STAFF REPORT SUMMARY

To: Edgerton Planning Commission
Fr: Kenneth Cook, AICP, CFM, Community Development Director
Re: FP2016-04, Final Plat for Midwest Gateway, located on the North side of 191st Street and 1,500 feet West of Kill Creek Road.

To: Edgerton Planning Commission
Fr: Kenneth Cook, AICP, CFM, Community Development Director
Re: FS2016-10, Final Site Plan for Midwest Gateway, located on the North side of 191st Street and 1,500 feet West of Kill Creek Road.

Final Site Plan Application No. FS2016-10
Final Site Plans Midwest Gateway

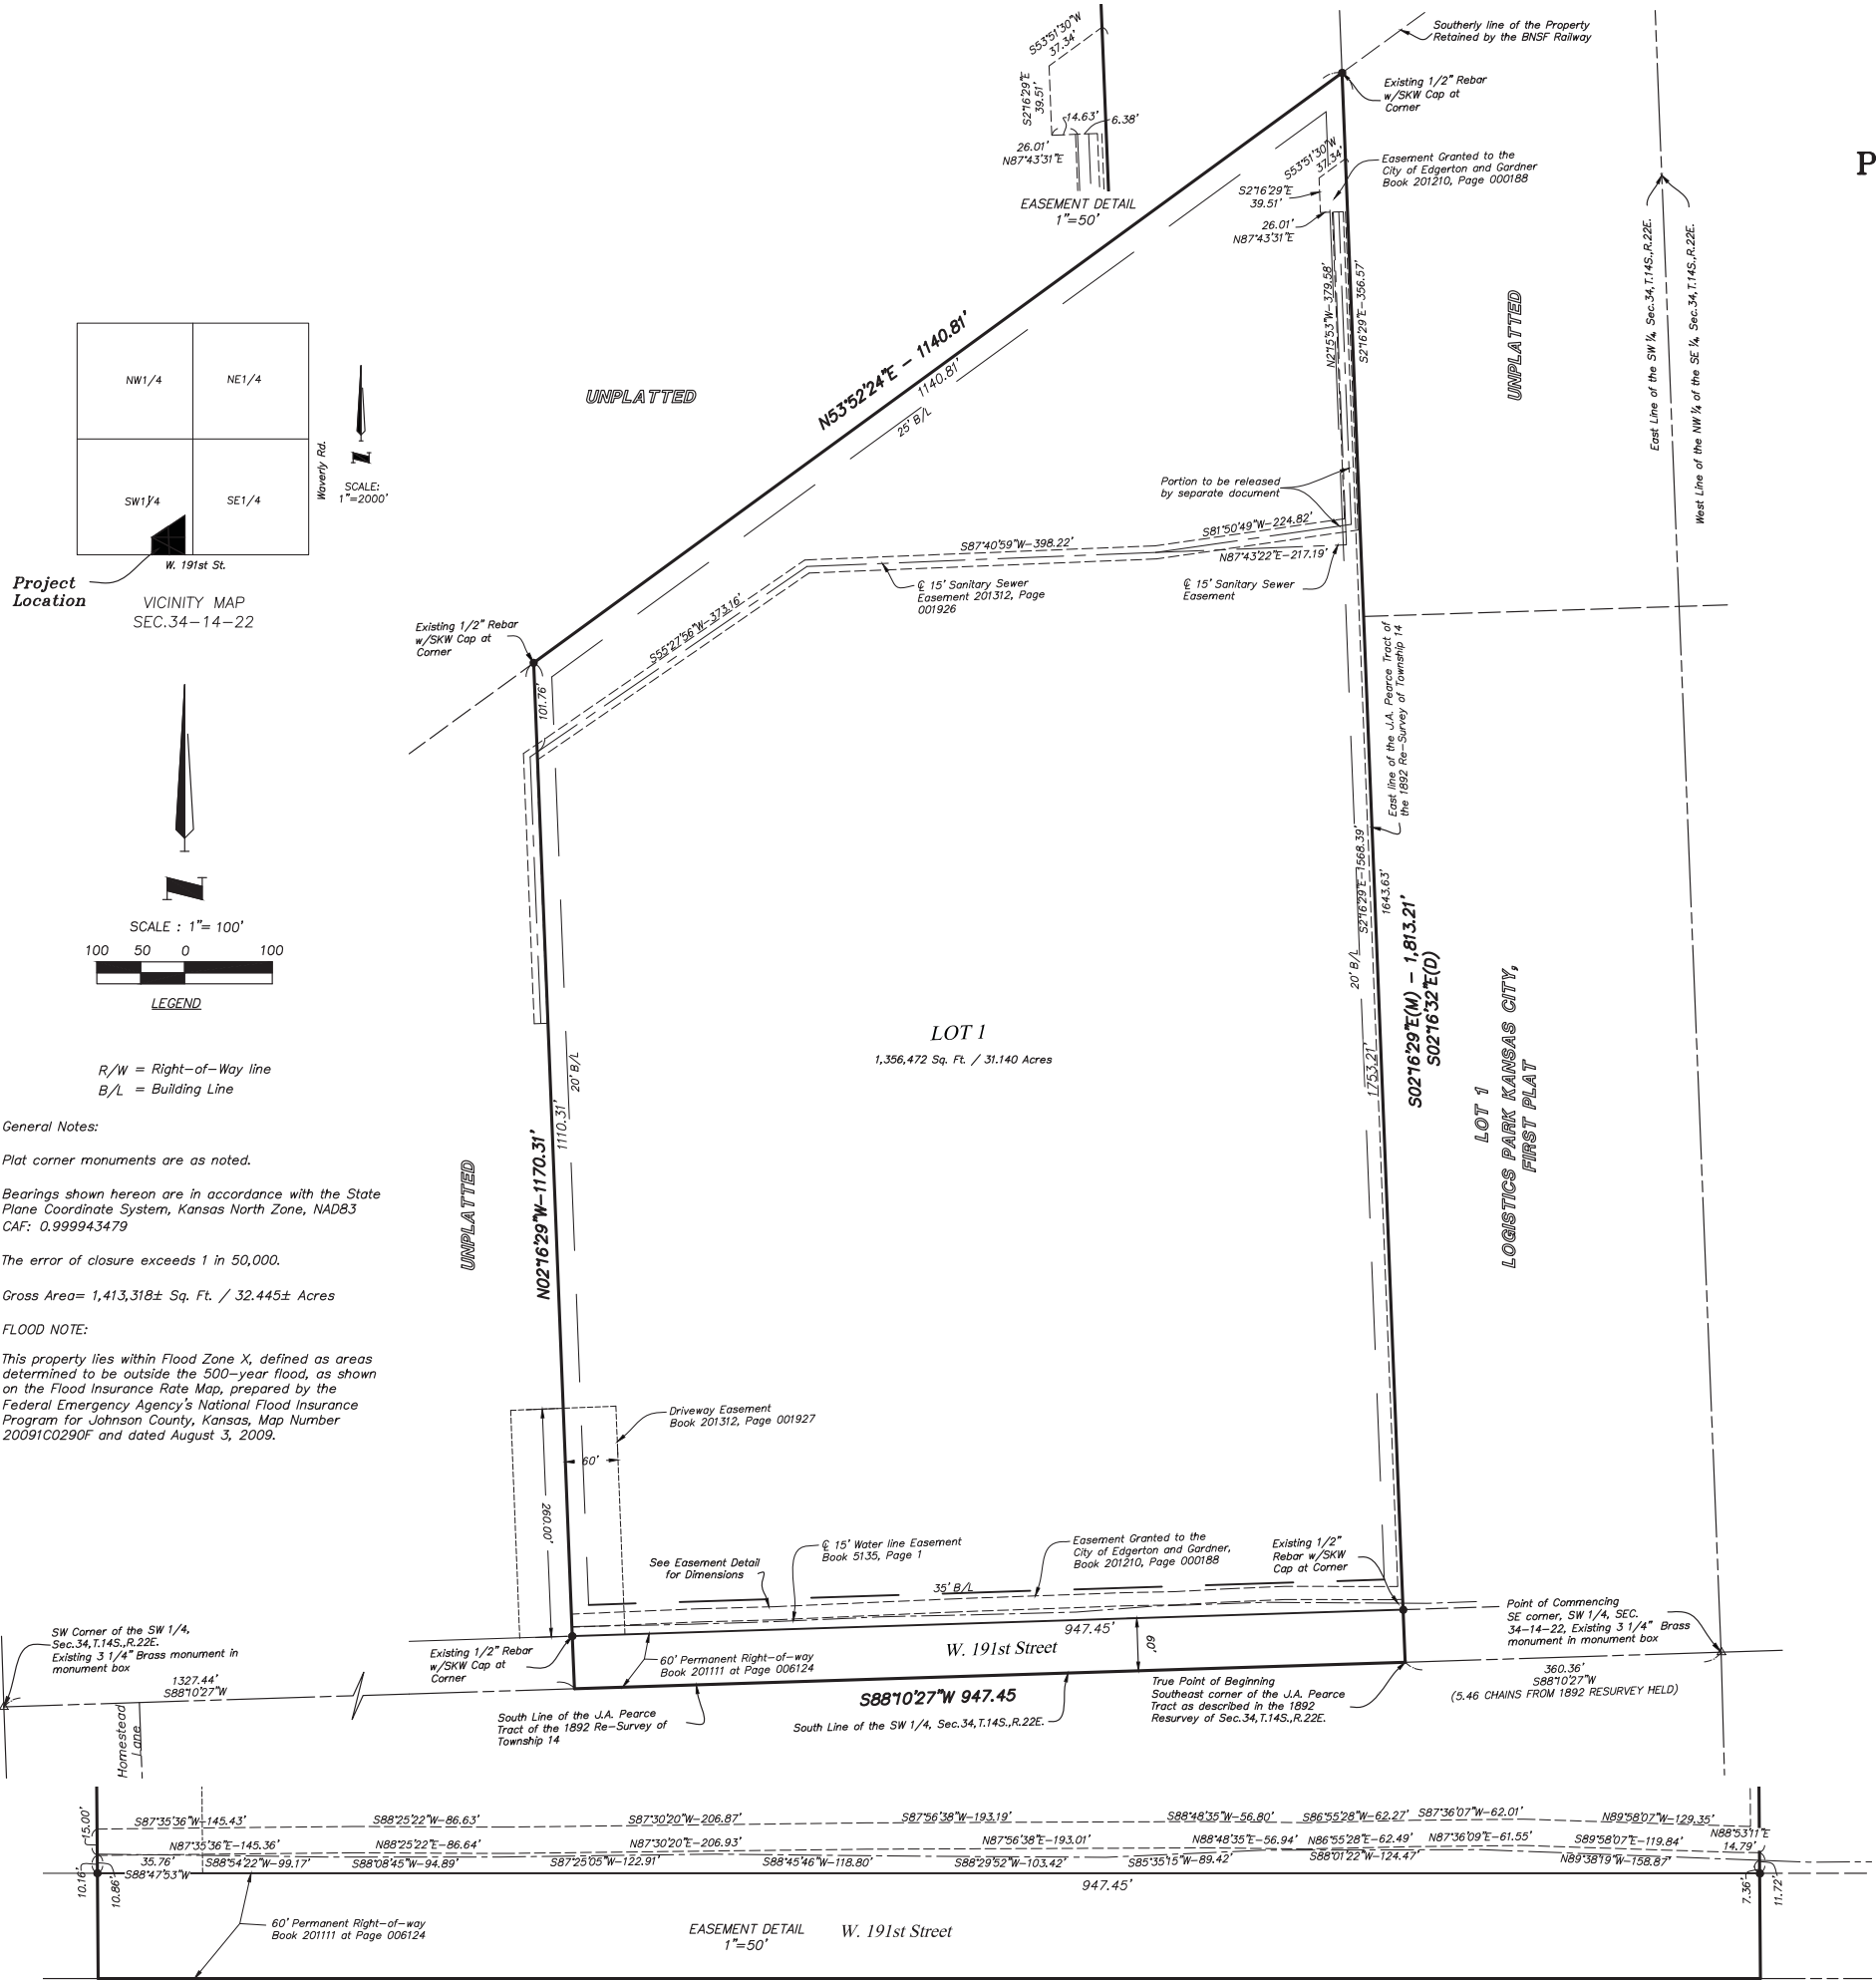
1. Include table showing lot area, setbacks and building envelope. Need to update setbacks to show a 50 foot front setback and 25 foot side setbacks.
2. Show a drainage easement for the detention pond.
3. Update the wording of the instrument of dedication.
4. Include certificate for Zoning Administrator.

5. Individual notations and a TABLE showing: lot area, setbacks, and building envelopes. *Please add table. Setbacks currently shown do not comply with L-P District requirements. Front setback should be 50 feet and side setbacks should be 25 feet. Update Final Plat.*

10. A written legal description from the survey. *Final Plat Complies.*
11. An instrument of dedication for all roads and easements. *The Final Plat includes language for the dedication of right-of-way (streets) and other types of similar rights-of-way including utility easements. The wording of these dedications needs to be modified to match the standard wording that the City of Edgerton uses. Update Final Plat.*

20. Certificate of the Zoning Administrator. *Language not present, please add. Update Final Plat.*

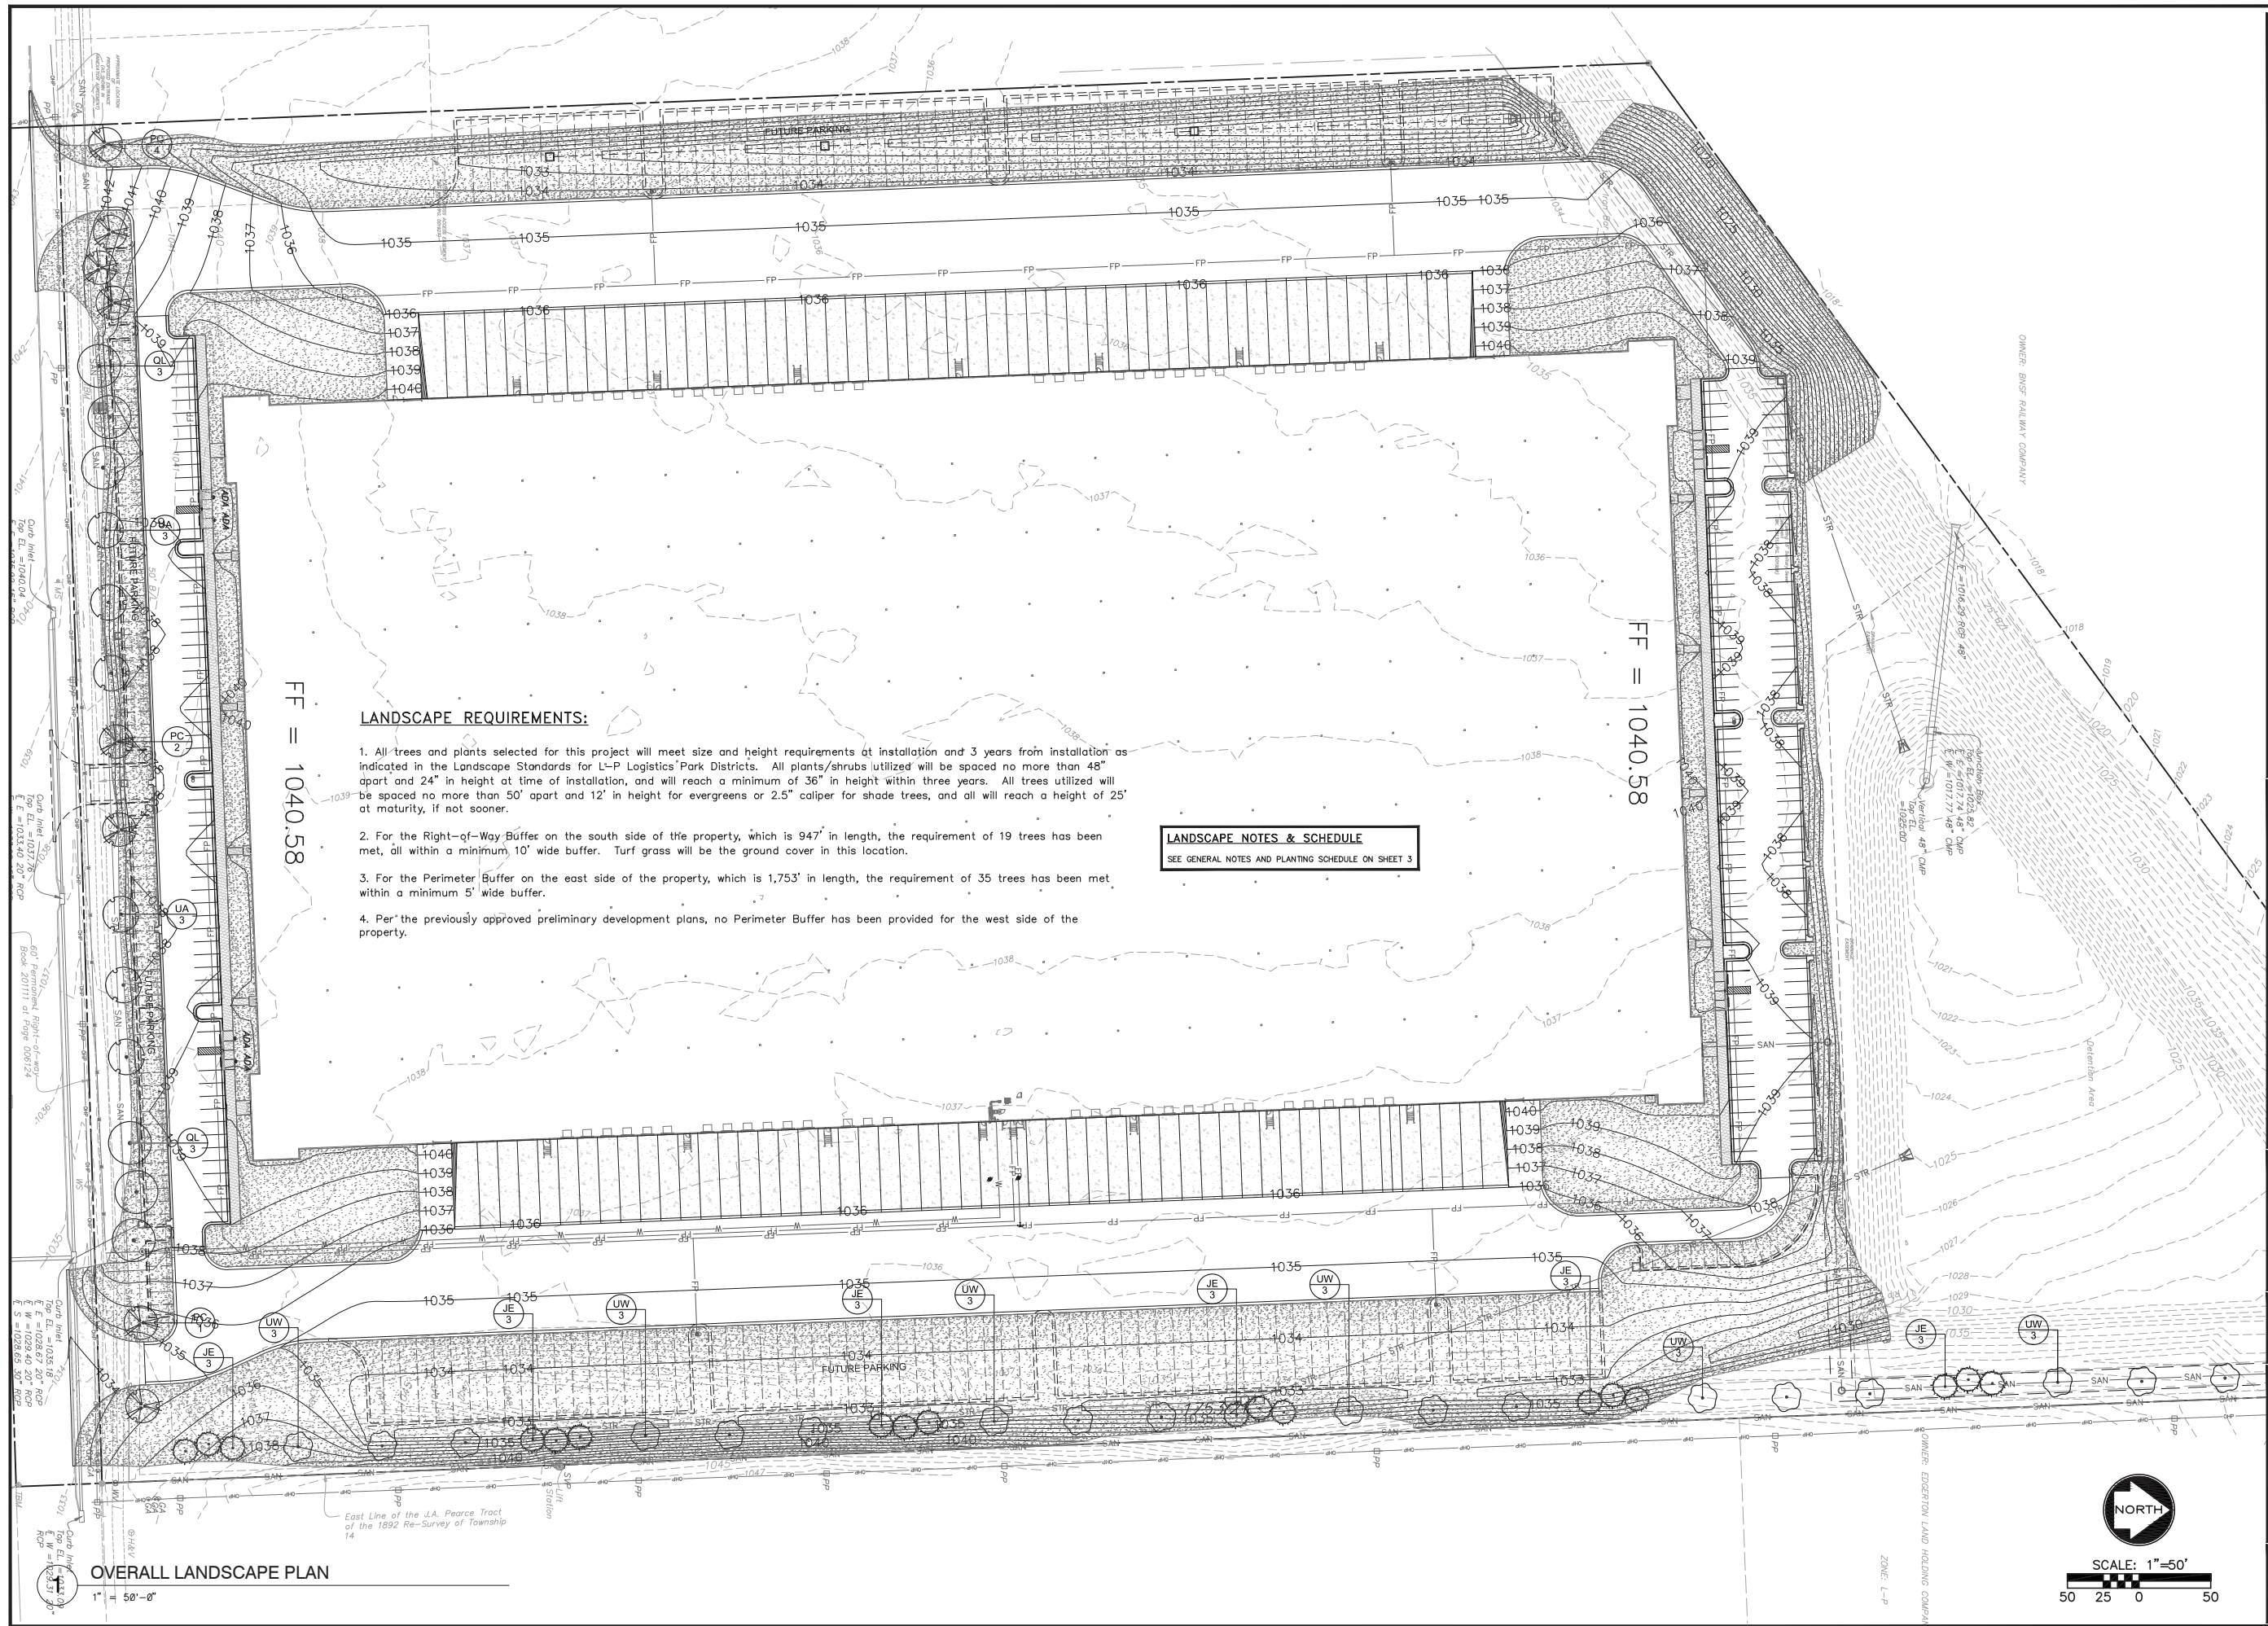
- d) The name of the architect, engineer, surveyor or draftsman. ***Final Site Plan Complies.***
- e) The specified certificates and signature blocks. *Need to be added to the cover page.*
Update Final Site Plan.

5. Accessory Building and Structure Regulations. There a two (2) guard sheds depicted on Sheet 1 of 12. Add their location to Sheet 4 of 12. Additionally, the guard sheds will need to be designed to match the architectural character of the building. ***Update Final Site Plan.***
